City of San José Dept. of Planning, Building, and Code Enforcement
attn.: Thai-Chau Lee, Environmental Project Manager
200 E Santa Clara St, 3rd Floor Tower
San José, CA 95113-1905
via email (Thai-Chau.Le@sanjoseca.gov), sent Sept. 24, 2021

re: NOP of Draft SEIR on Milligan Parking Lot, file ER20-049
<https://www.sanjoseca.gov/home/showpublisheddocument/76437/637653190570070000>

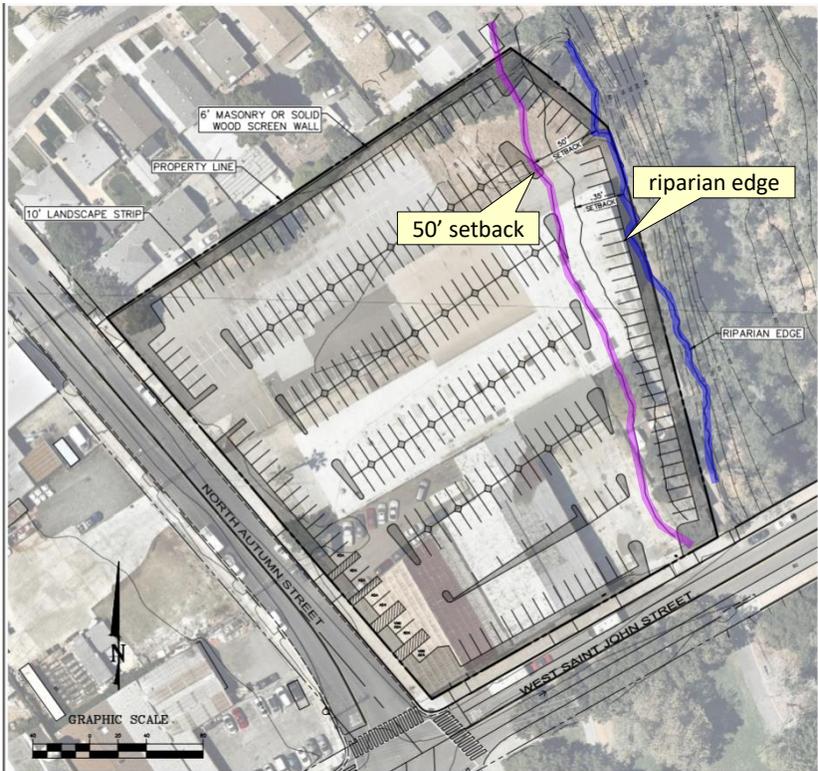
However, the project proposed here by the City violates the City’s own ordinances by not even providing the *minimally* required setbacks. Indeed, the plan even calls for a masonry or solid wood wall in places to be built *within* the riparian corridor itself.

- If the City grants itself a waiver, how can it deny any future waiver request? “Do as I say, not as I do”?
- What are the impacts of construction so close to the bank? What are the bank stabilization and flood-control issues?

- Will the City be liable for future flood protection or bank stabilization?
- What is the impact on native riparian fauna such as beaver?
- What is the impact on the migrating bird flight corridor?

- How many parking spaces could be provided if the project were designed in compliance with the City’s riparian setback policies? Does the difference between the as-proposed and this number comprise an overwhelming need that justifies the overriding of the City’s riparian policy?

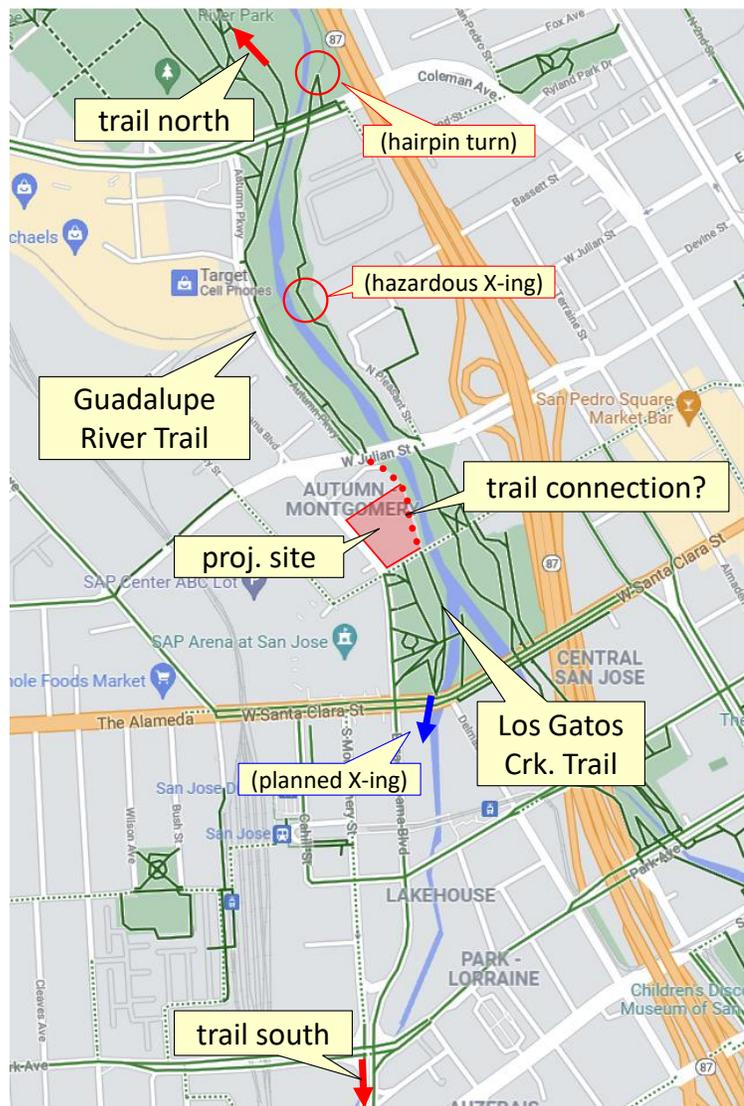
San José has a world-class trail network. The project site is the ideal location for the connection of the Los Gatos Creek Trail and the Guadalupe River Trail, as shown to the right by the dotted red line. The City, I believe, had once planned for the trail connection to be made by on-street bike lanes, but that was to have been along the no-longer-planned Autumn Parkway extension.

Some years ago, we on the County’s Los Gatos Creek Streamside Park Committee found that it was best to capitalize on opportunities when presented by development projects. By making the City’s plans compliant with the City’s own riparian corridor setback policies, there would be adequate space for the off-road trail connection while still protecting and enhancing the natural environment.

Note that the trail on the left-bank (west side) of the Guadalupe is the through route to the north, and the trail to the south of the project aligns with a planned overcrossing that is part of the DSAP.

- What would be the impact to the Vehicle Miles Traveled (VMT) by enabling a safe connection of two regional trails?
